ADDENDUM NO. 01

Project Name: LONGVIEW SCHOOL DISTRICT
MONTICELLO MS CEILING TI

Johansson Wing Project #: 23017
Date: JULY 14, 2023

A232A

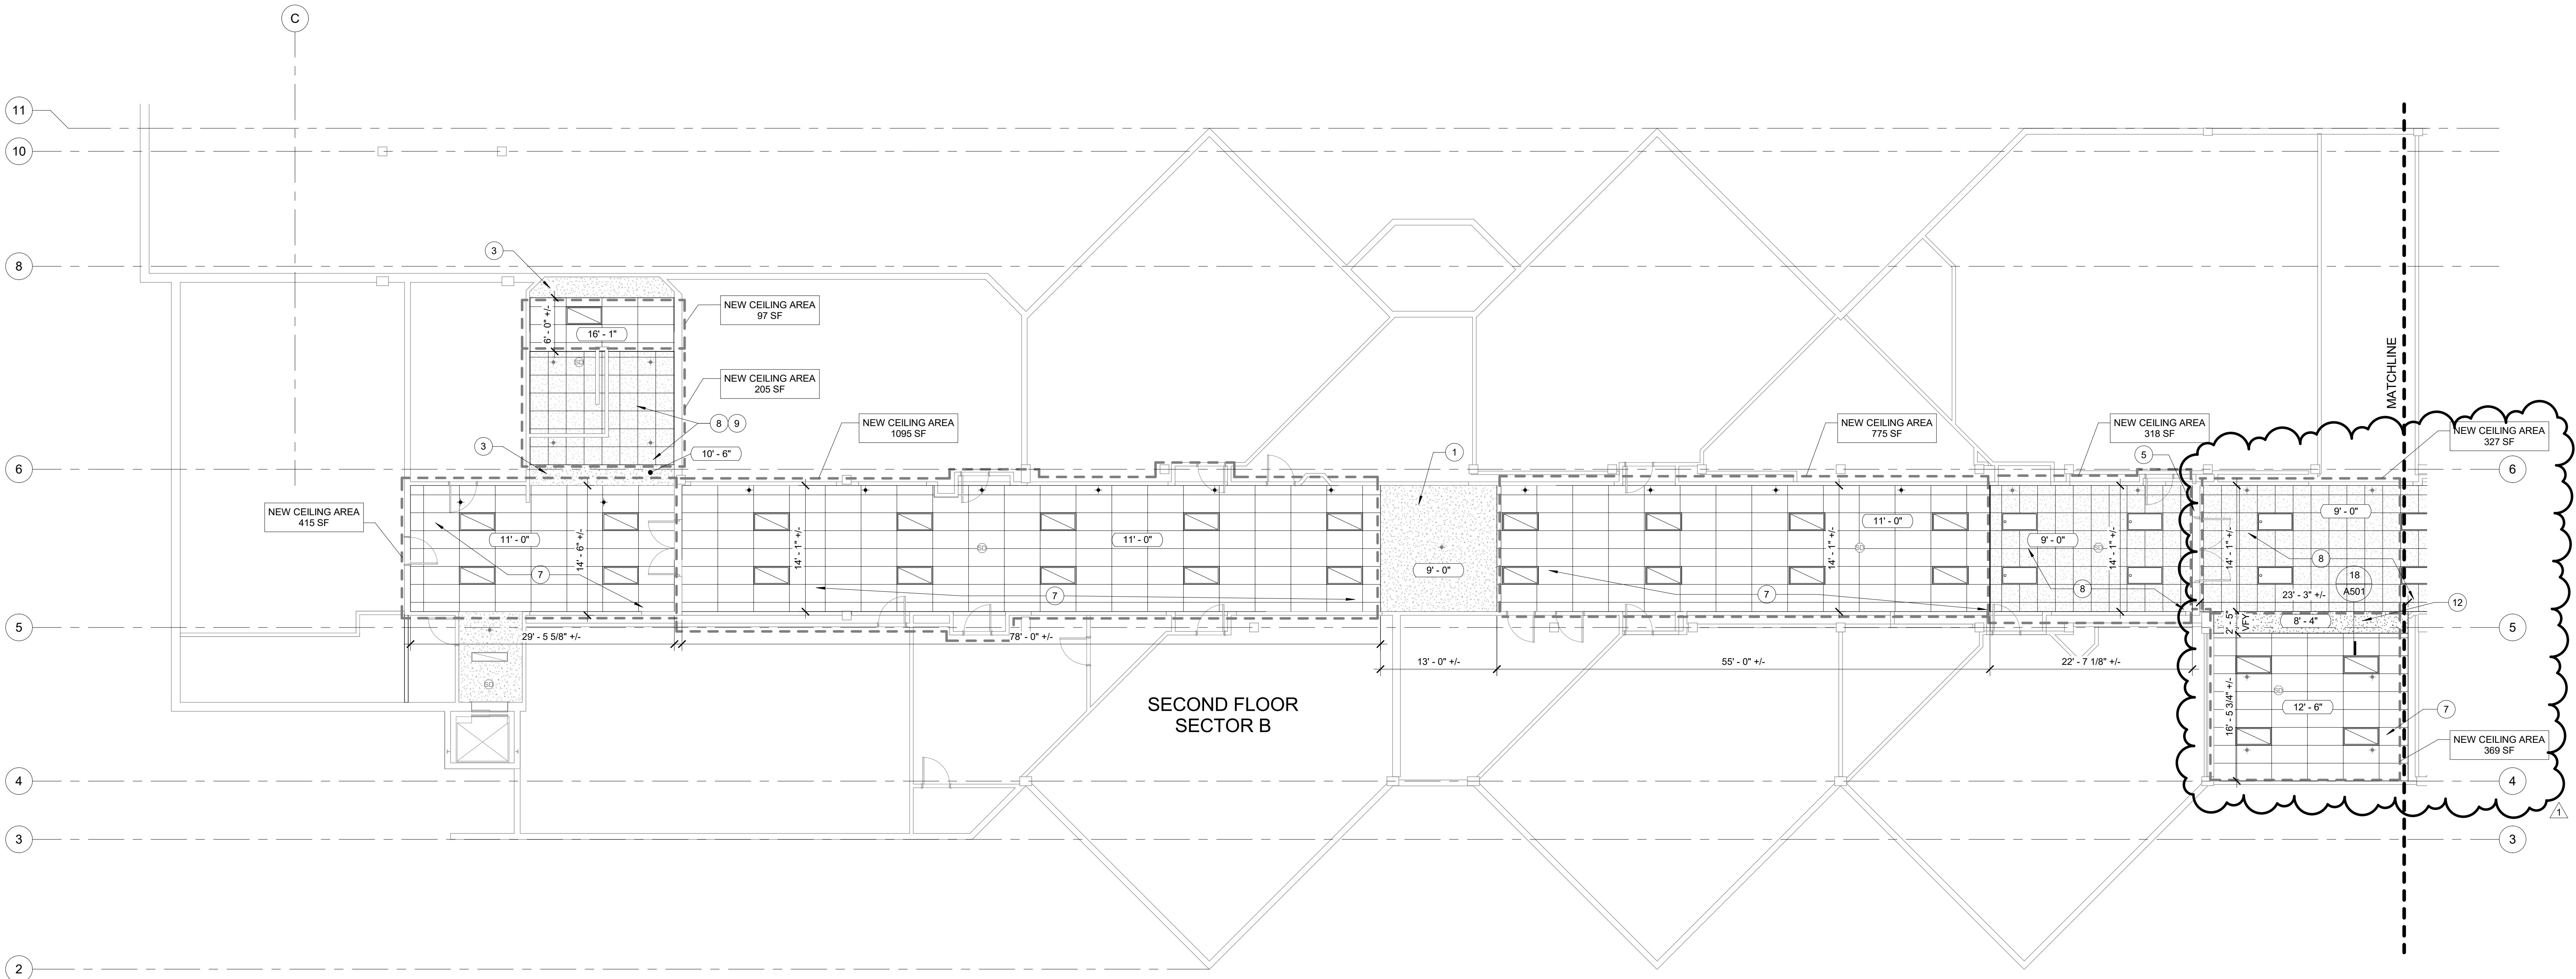
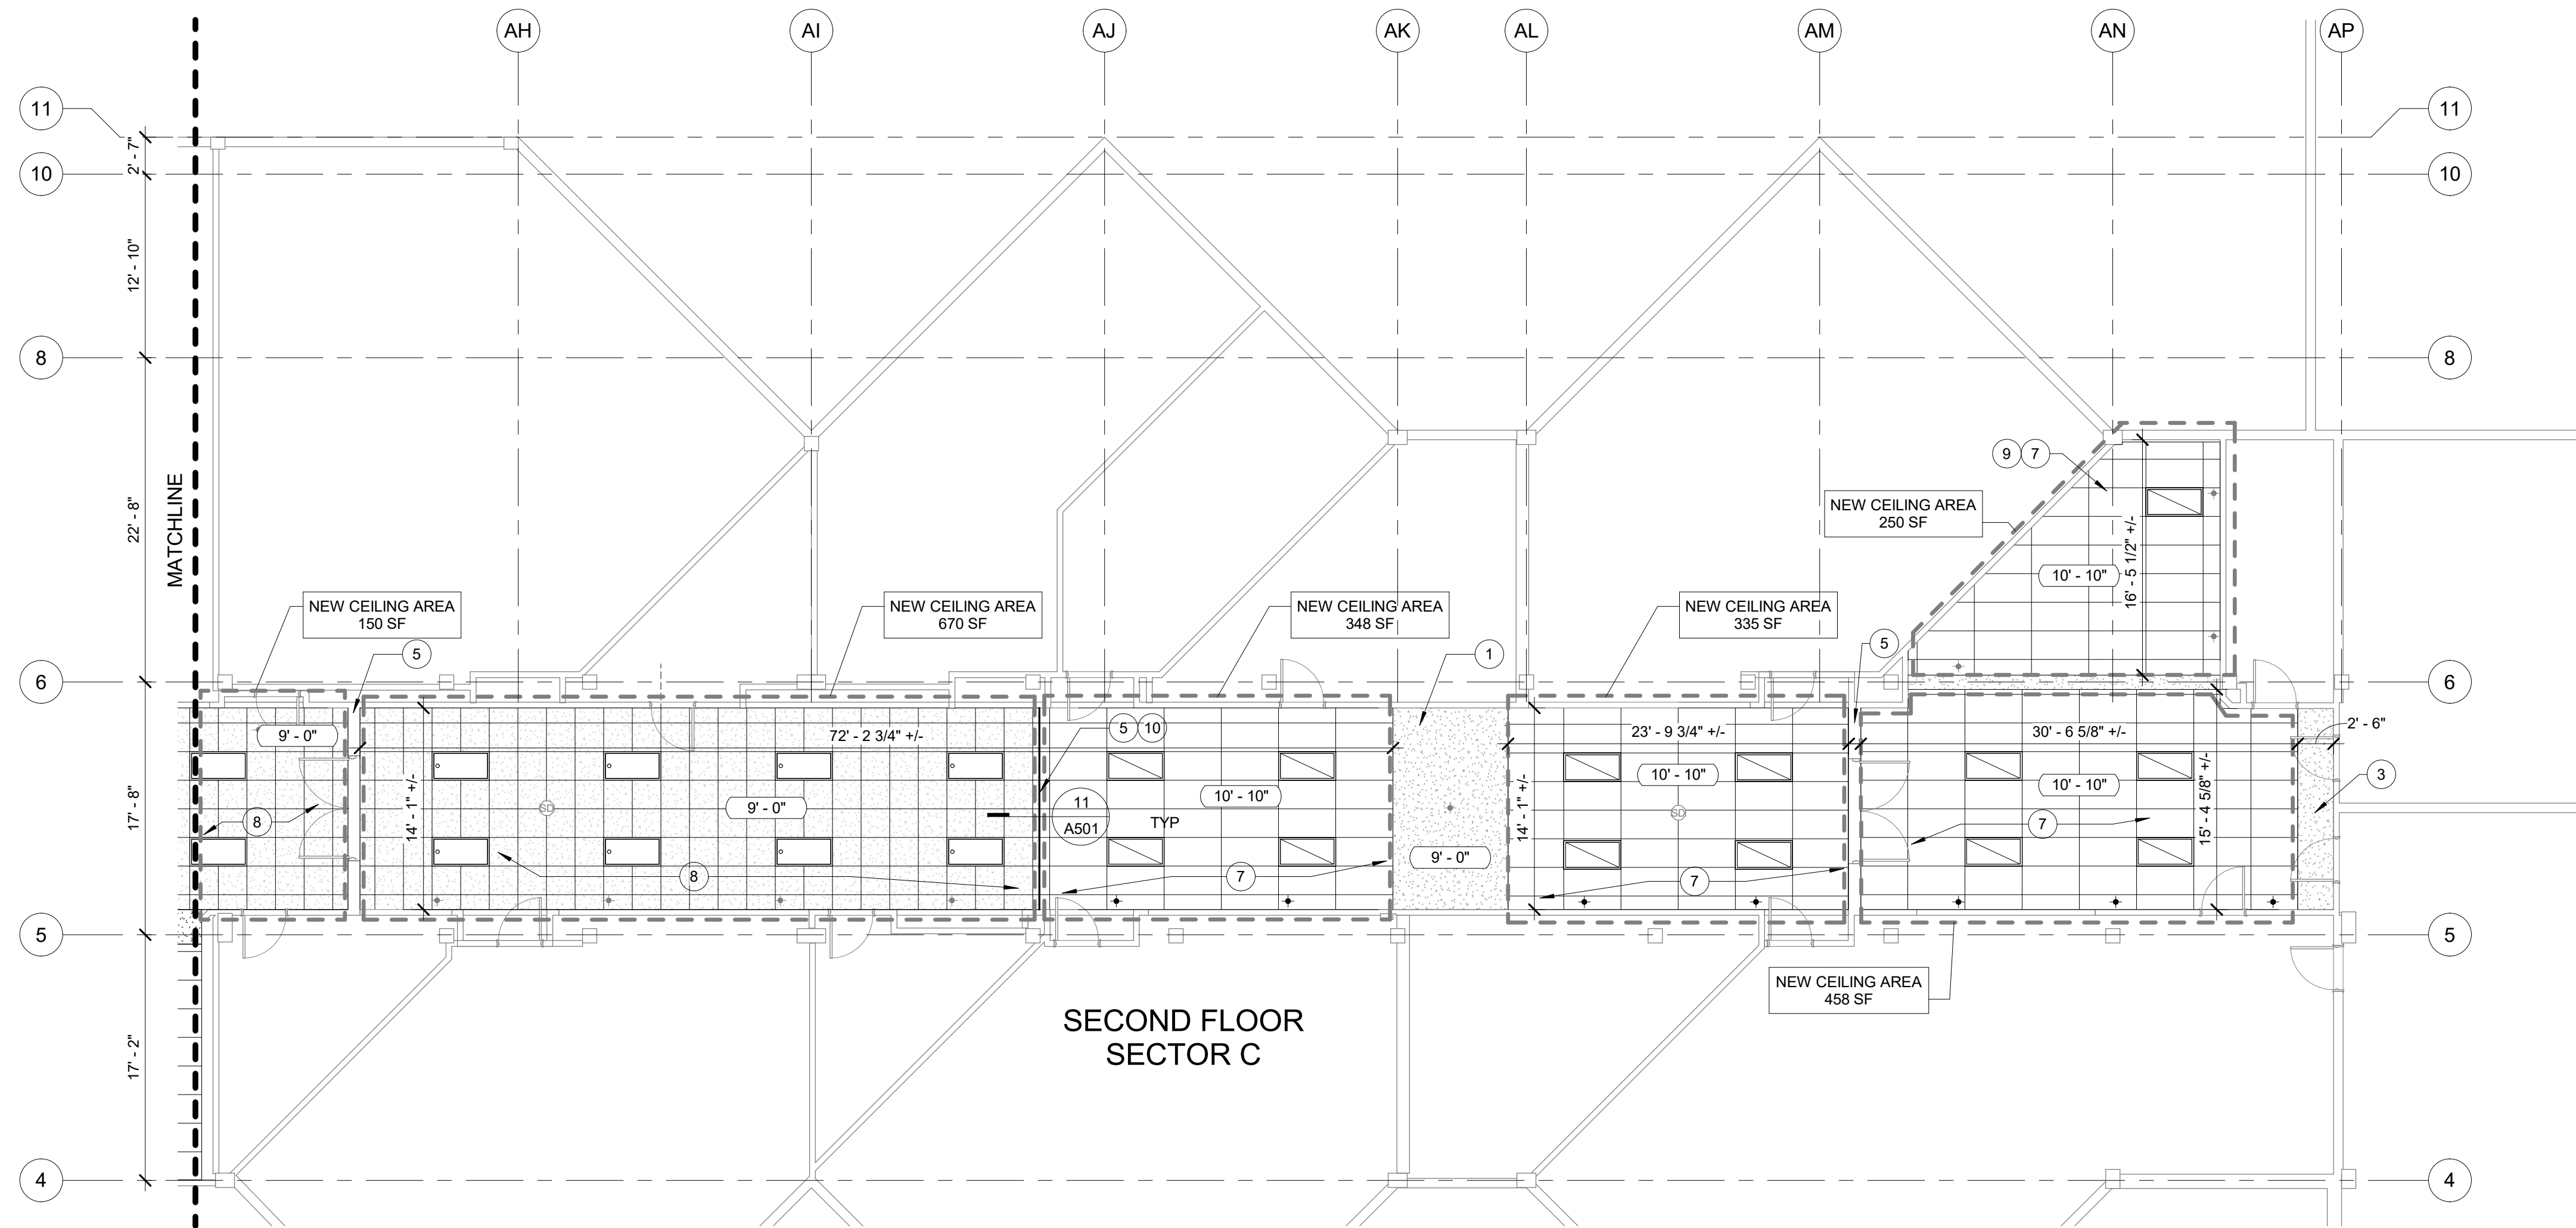
1.11	Soffit Details	<i>Provide soffit details as described in the walk at the high ceiling for the second floor near stairs.</i> Response: updated sheets A232A & A501 will include the soffit location and details.

Item #:	Sheet/Detail:	Description:
1.13	A232A, A501	New gypsum board soffit added for transition at stair suspended ACT and adhered acoustical panel ceiling.
1.14	M0.0	Revised- Basic Fire Suppression specifications on sheet
1.15	E000	Revised "General Electrical Requirements"
1.16	ED231A, ED231B ED231C, ED232B ED232C	Revised Keynotes for wire mold and raceways
